**Proposed Development
At
63-71 High Street, Hampton Hill
TW12 1LZ**

JOINT MEMORANDUM

Proposed Drainage Strategy

DRAWING TITLE
DRAINAGE LAYOUT AT GROUND FLOOR LEVEL

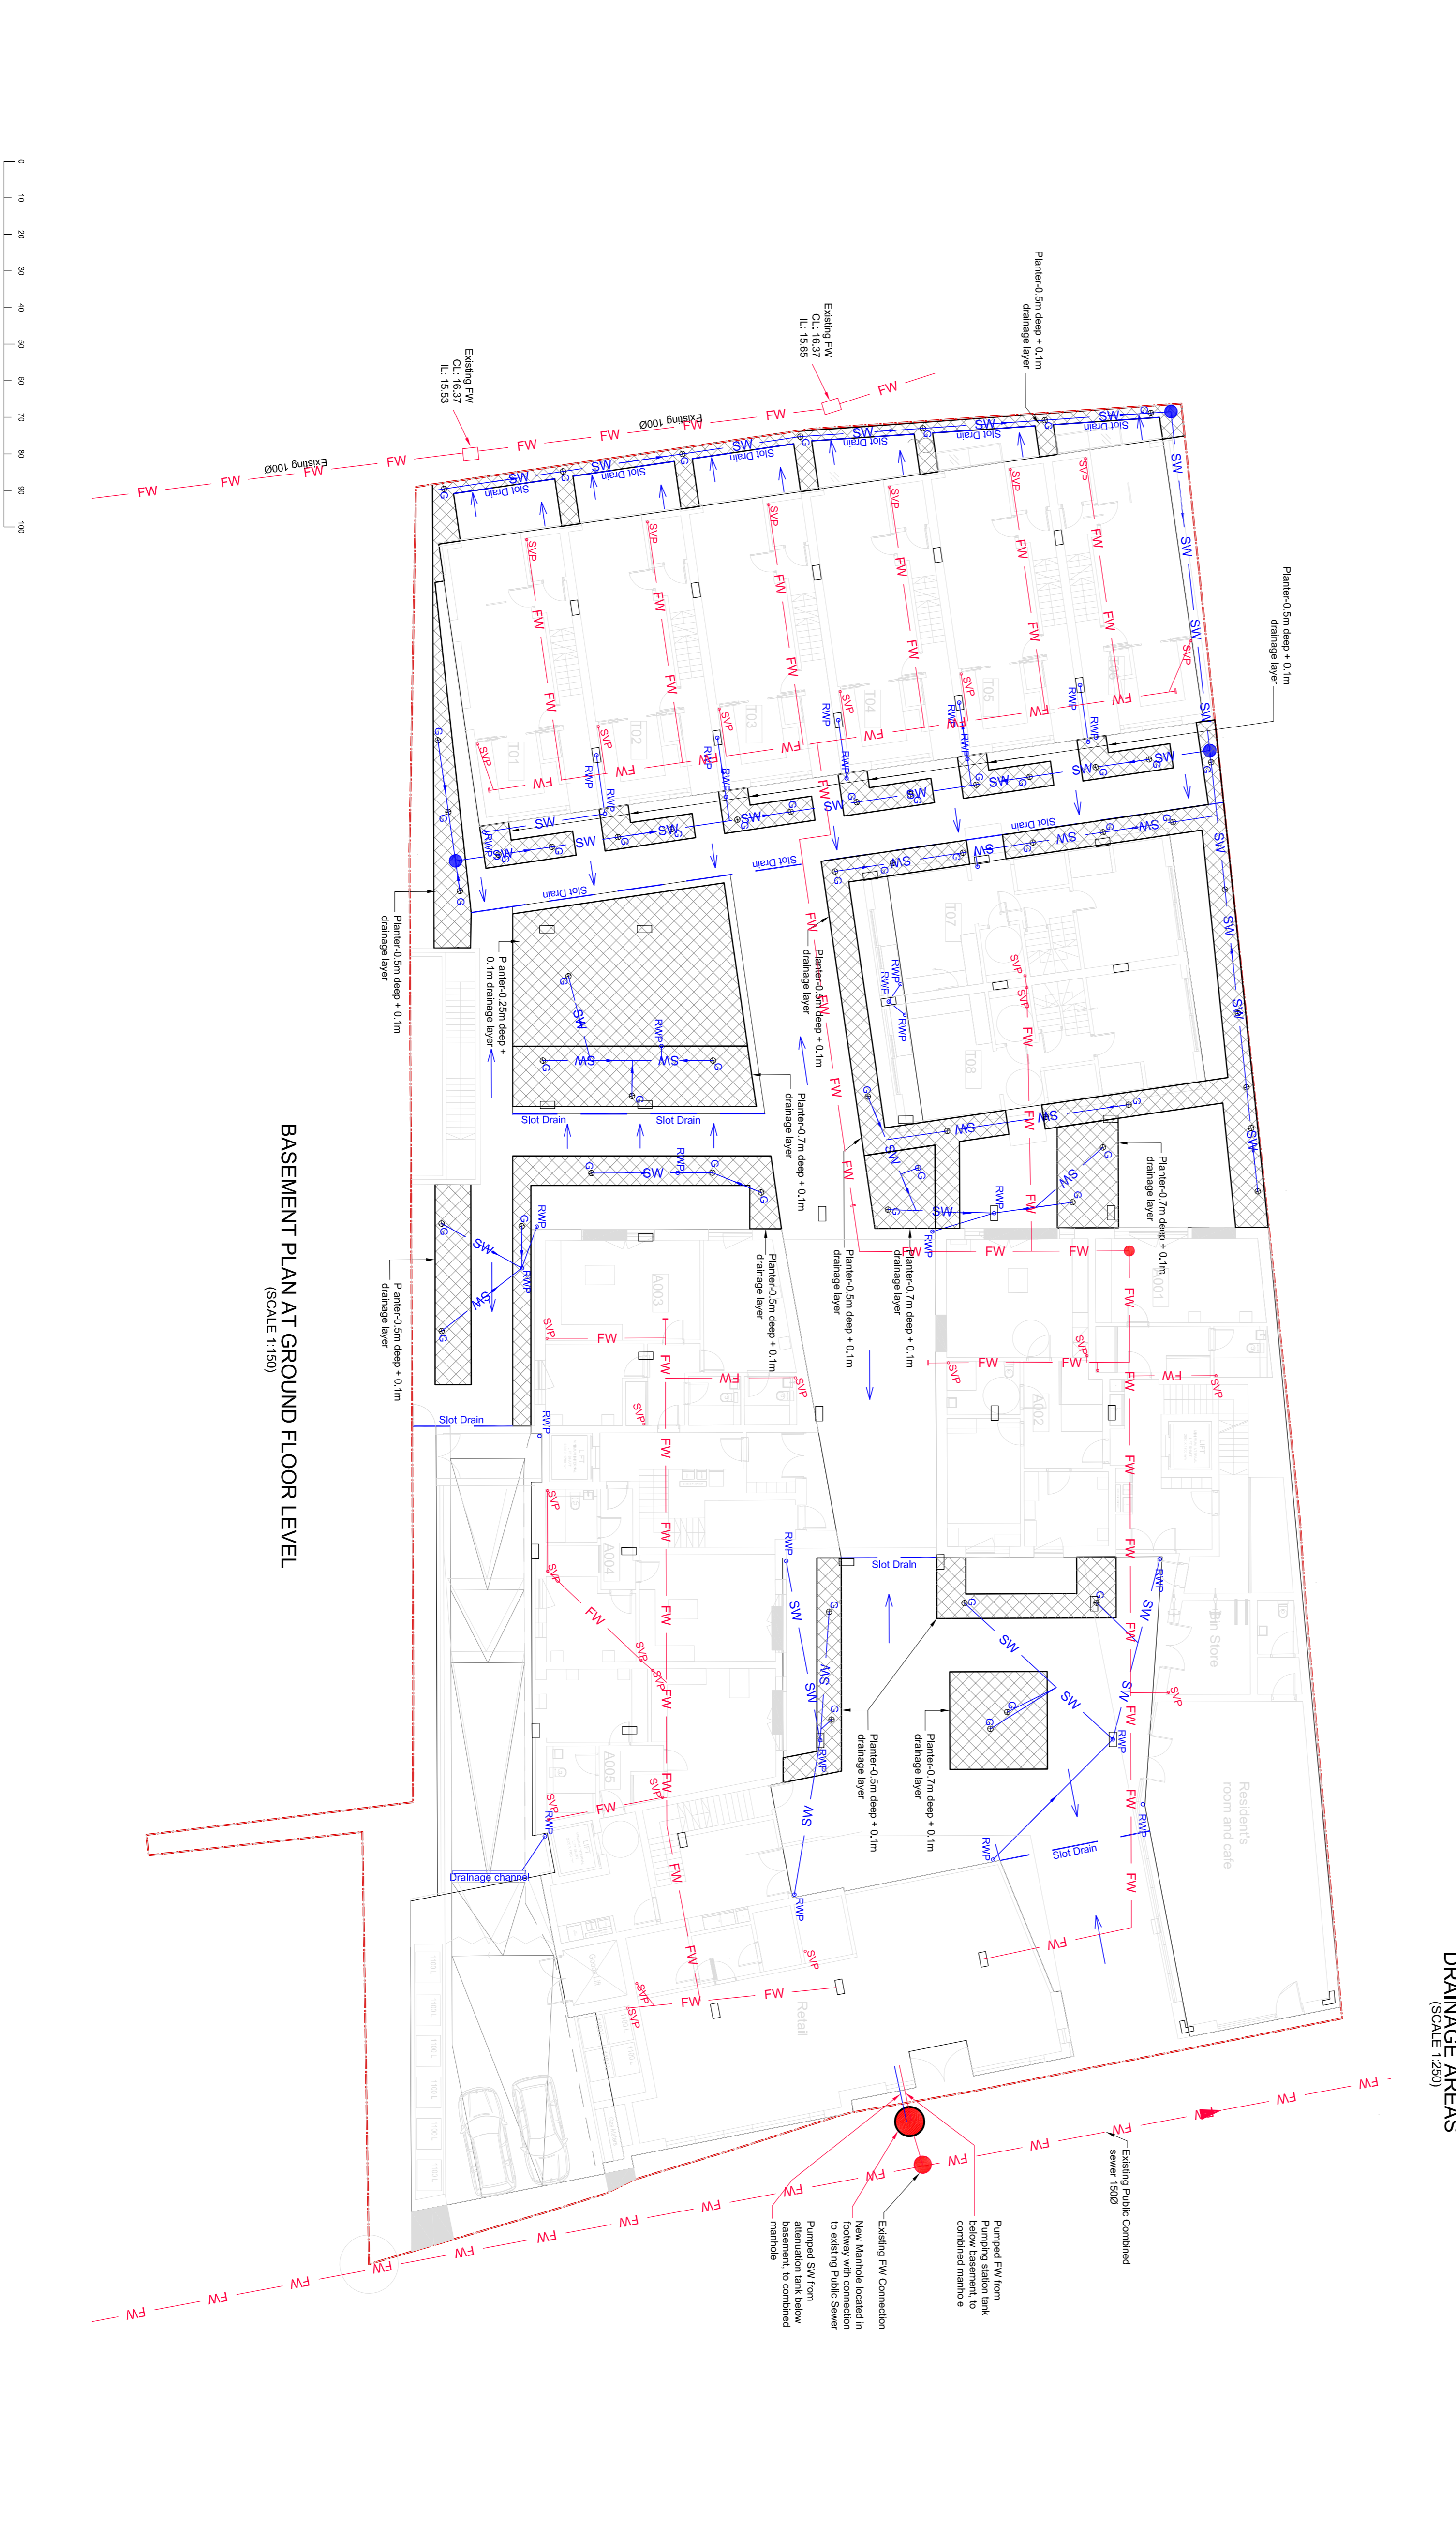
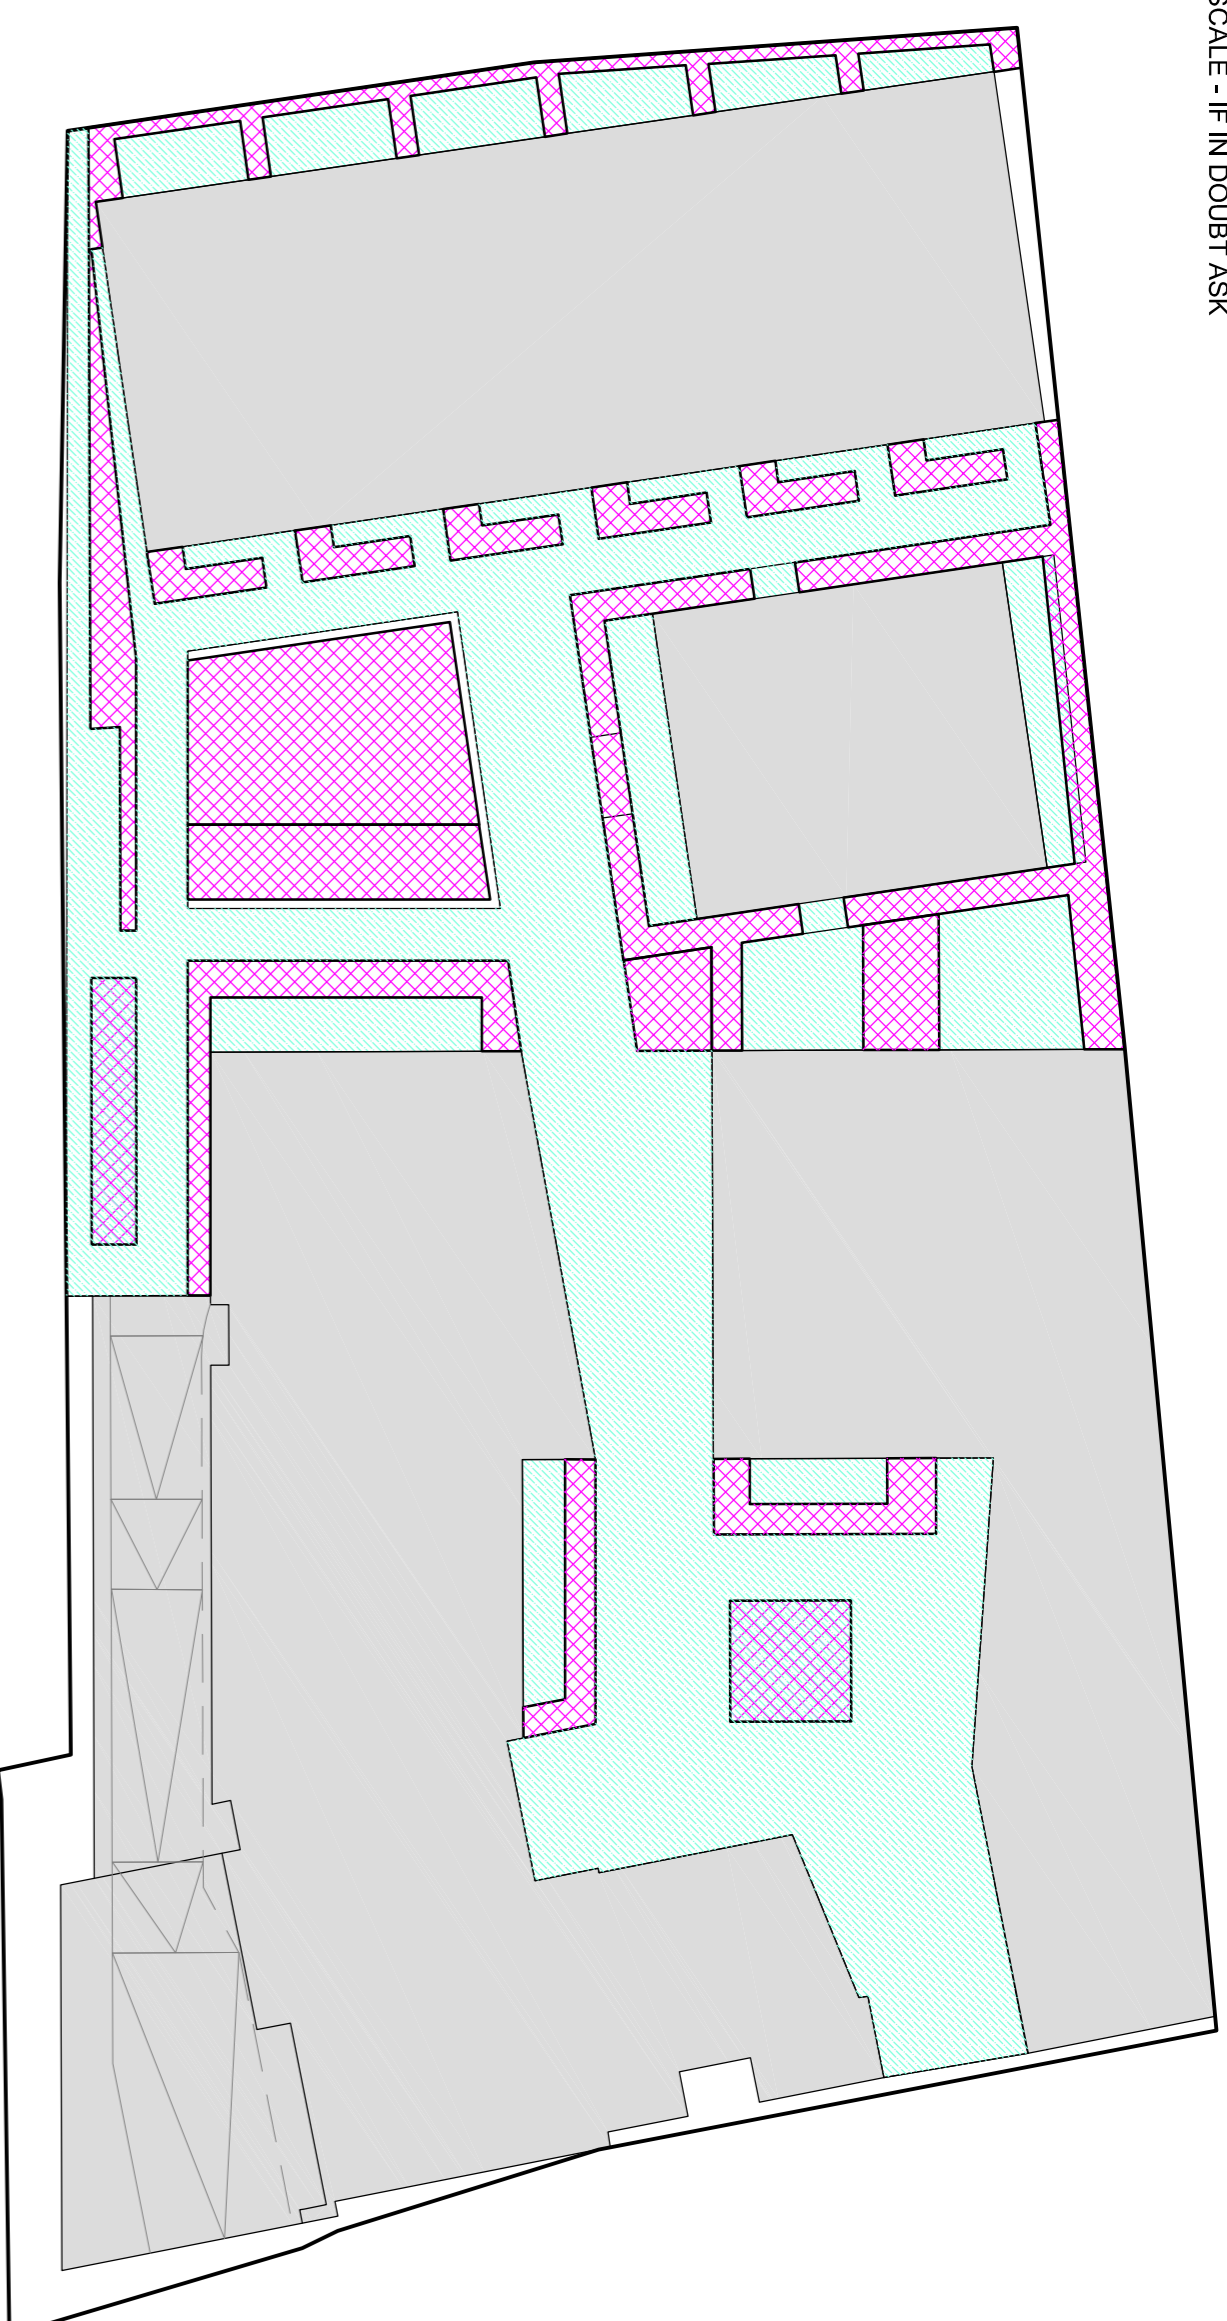
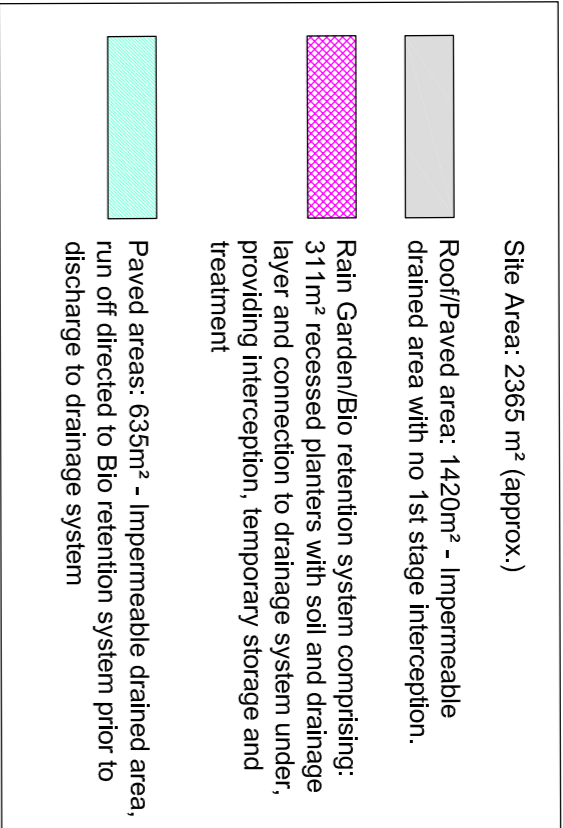
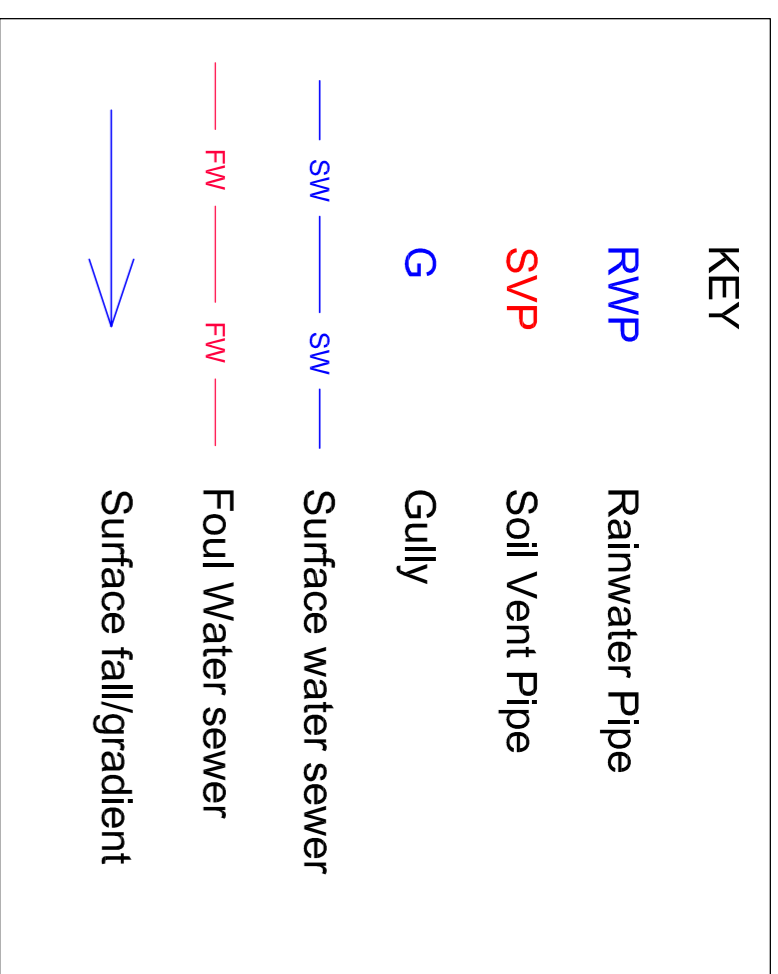
RAB Consultants' FRA has included in 'Appendix B – Drainage Design', drawing number SL05030.401 (no revision) prepared by HBPW LLP. This drawing shows the

surface water from the development being connected to an existing Surface Water sewer in the High Street and the foul water from the development being connected into an existing Foul Water sewer in the High Street. This is contradictory and inconsistent to the proposals set out in HBPW LLP's Drainage Strategy.

Drawing SL05030.401 (no Revision), included in RAB Consultants' FRA does not show the correct proposed drainage strategy, HBPW LLP Drainage Strategy and proposals shown on drawings SL05030.401 rev B and SL05030.402 rev B included in Appendix 4 of the Drainage Strategy and included again in Appendix 1 of this Memorandum is the correct drainage strategy for the development.

When reading the RAB Consultants FRA; drawing SL05030.401 (no revision) should be replaced with drawings SL05030.401 rev B and SL05030.402 rev B.
